Historical Areas Board of Review(HABR)

Project Name: B. Meyer 23 Closter Rd, Palisades #1

Changes were made to the original plans based on the following:

Approved on original plan and what was used instead.

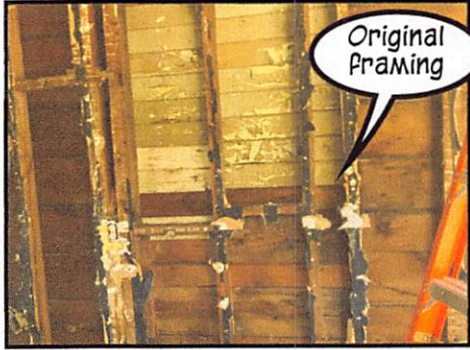
Kitchen window

Termite
window

New
window

1950's bow window
that did not relate to
1880's house

A-101

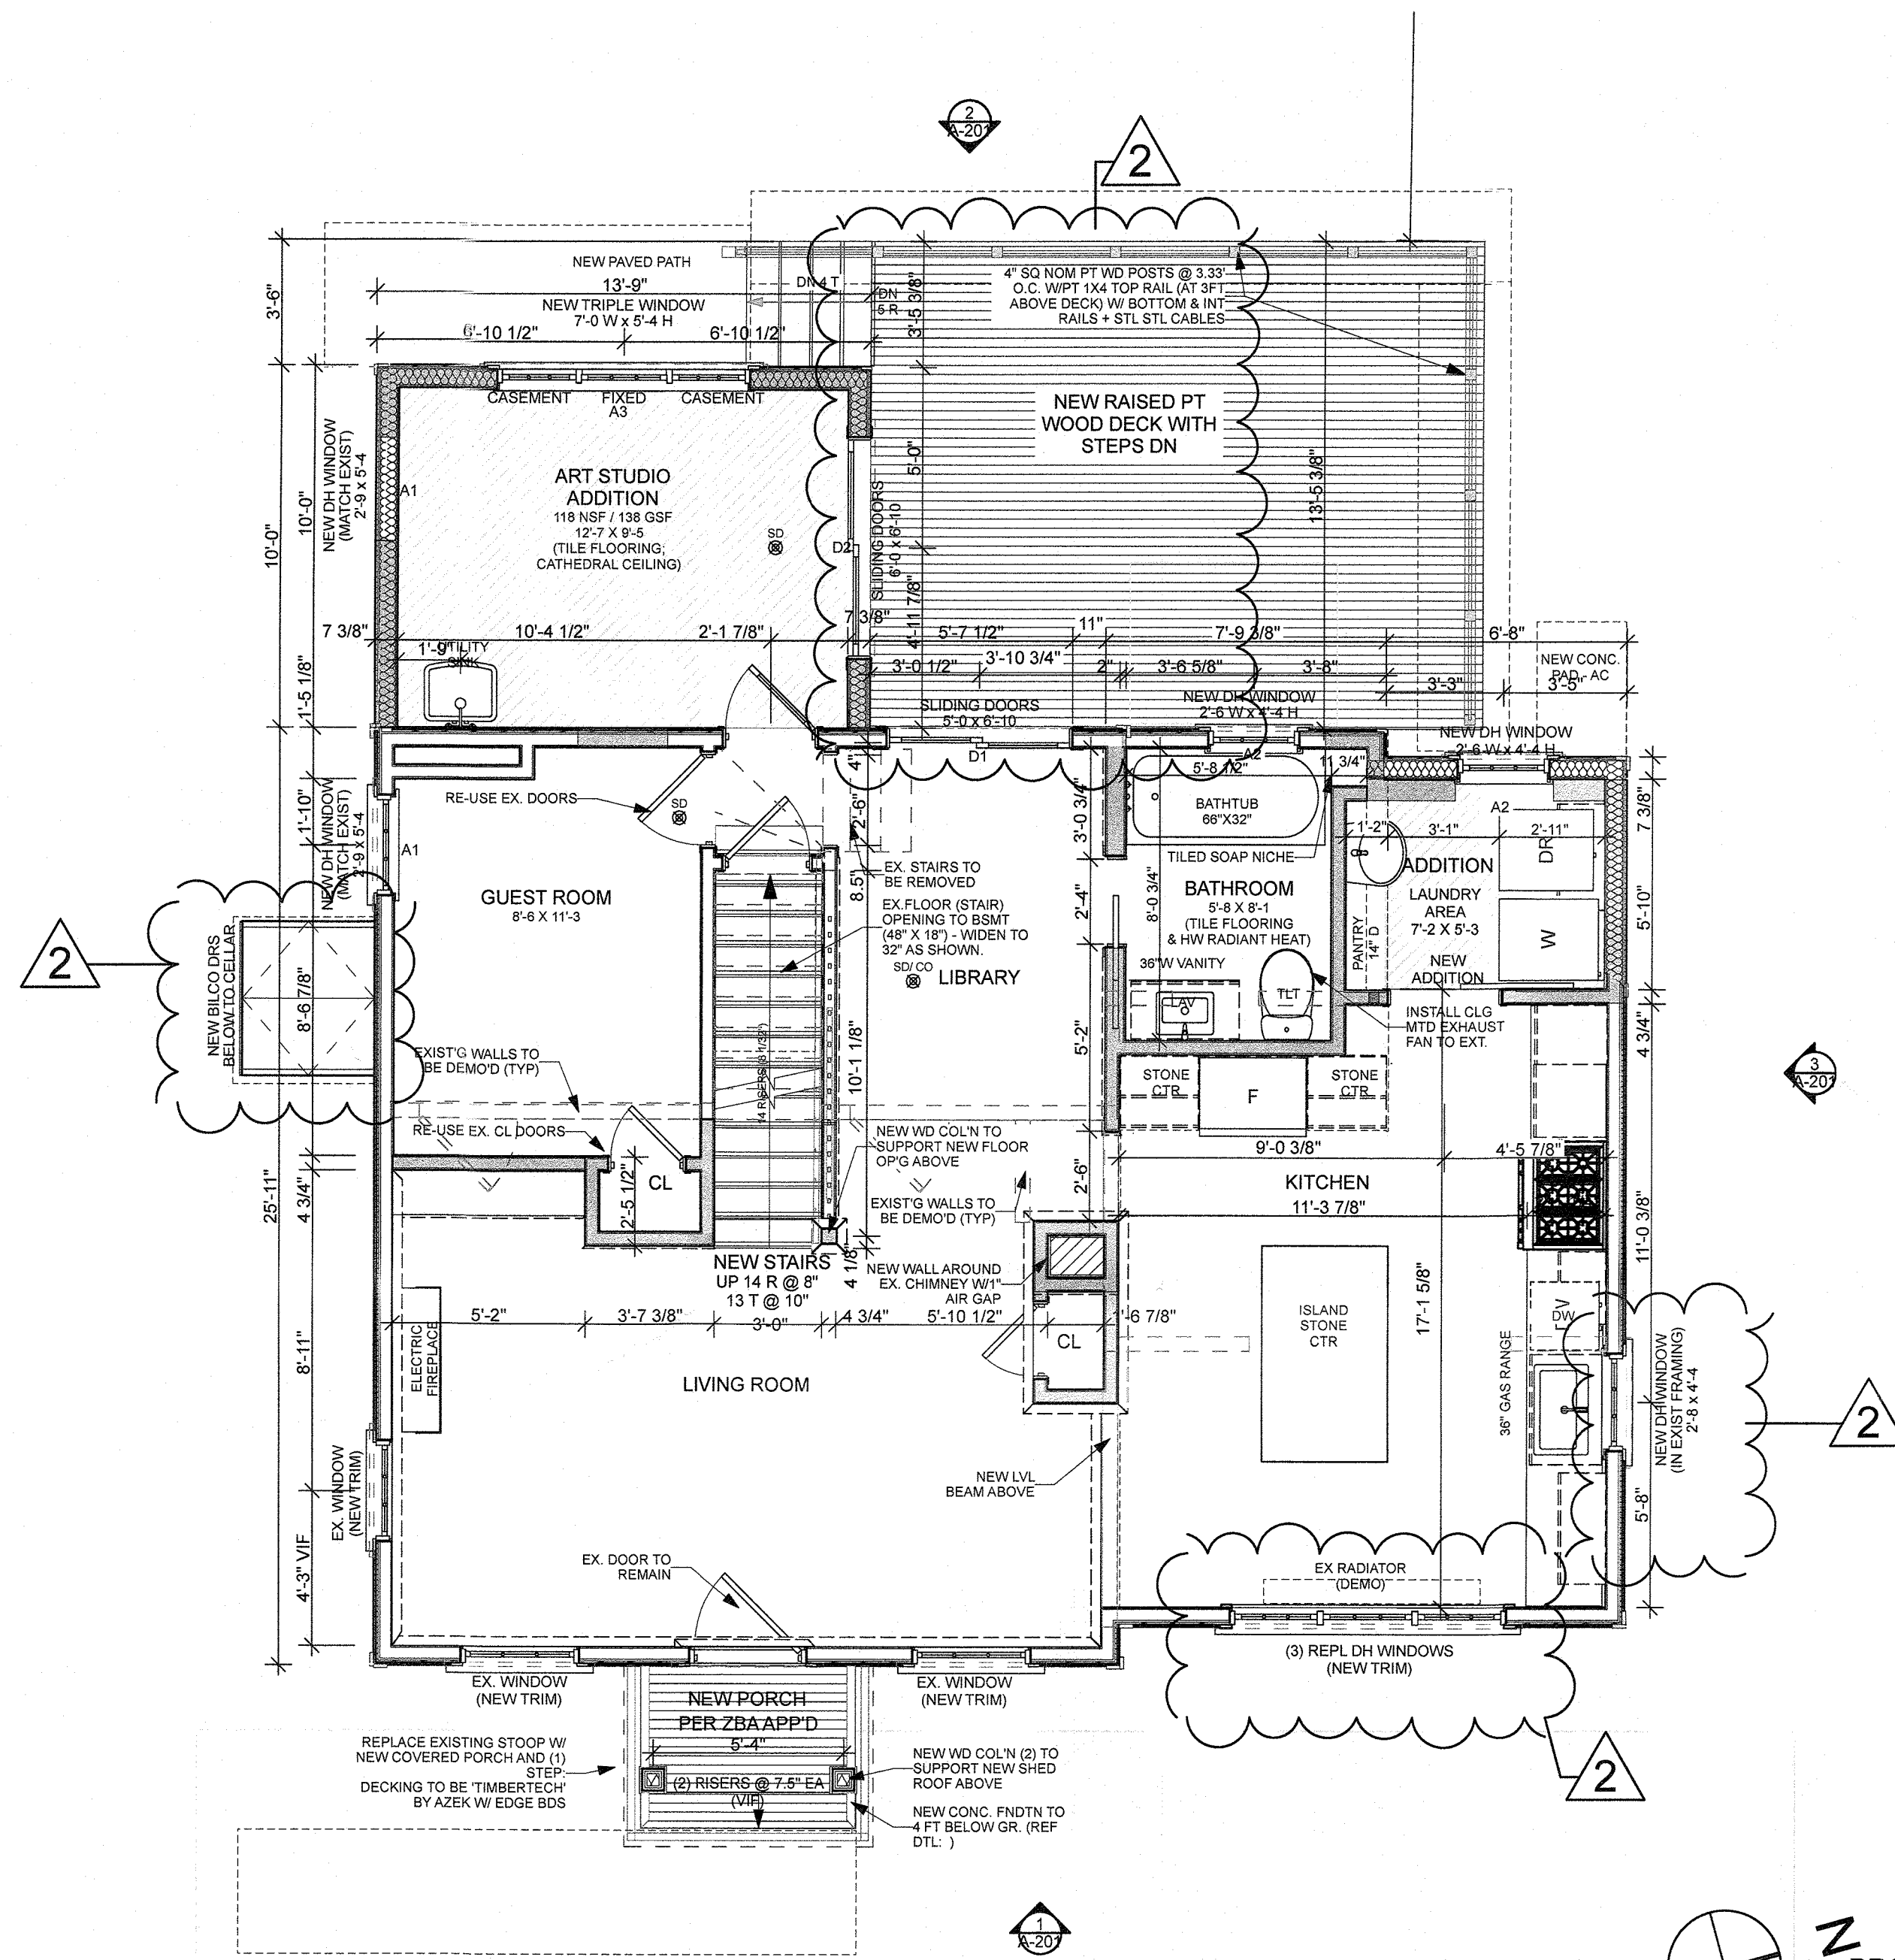
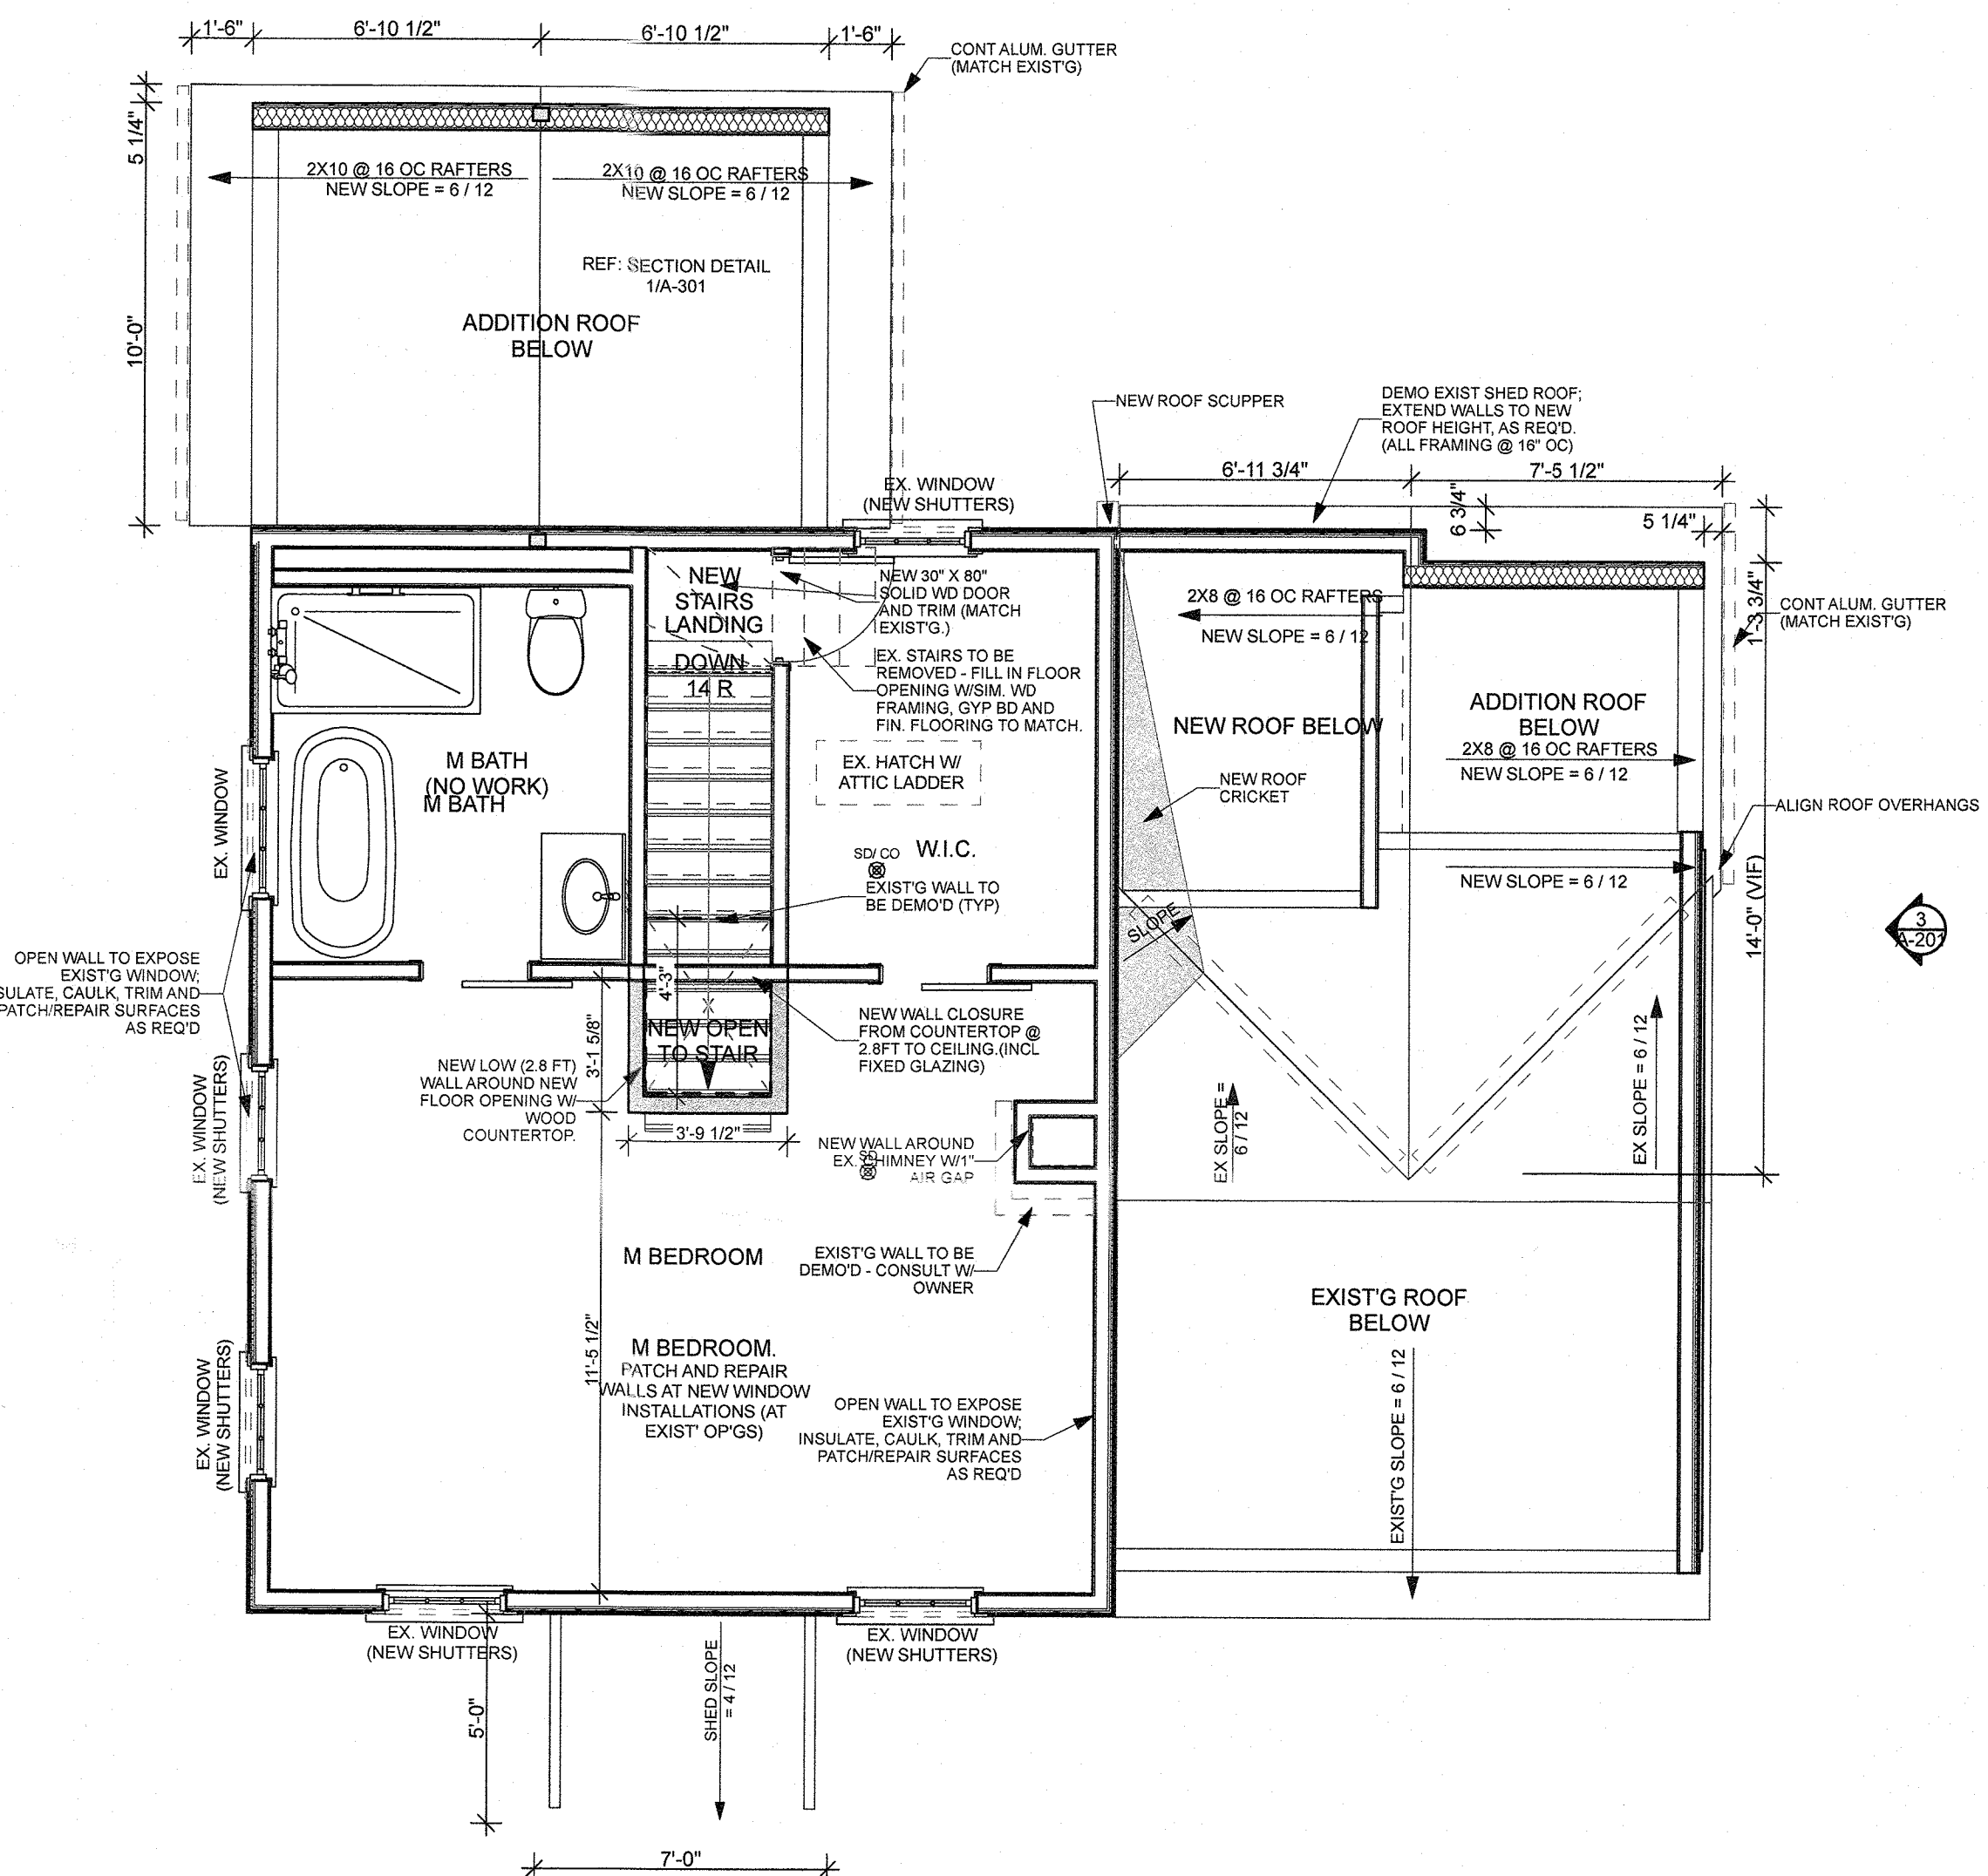
NOTE: ALL WINDOWS AND PATIO DOORS TO BE MI VINYL CLAD WINDOWS & DOORS, (MI 1600 SERIES, LOW-E, ARGON GAS, DUAL GLASS PANE; WINDOWS (U-VALUE = 0.27 (MIN), SHGC = 0.26; SLIDING PATIO DOORS (U-VALUE = 0.28, SHGC = 0.25); COLOR = WHITE.
(NOTE: NEW WINDOW A4 - REPLACED EXISTING BOW WINDOW, DUE TO INSECT DAMAGE AND ROT)
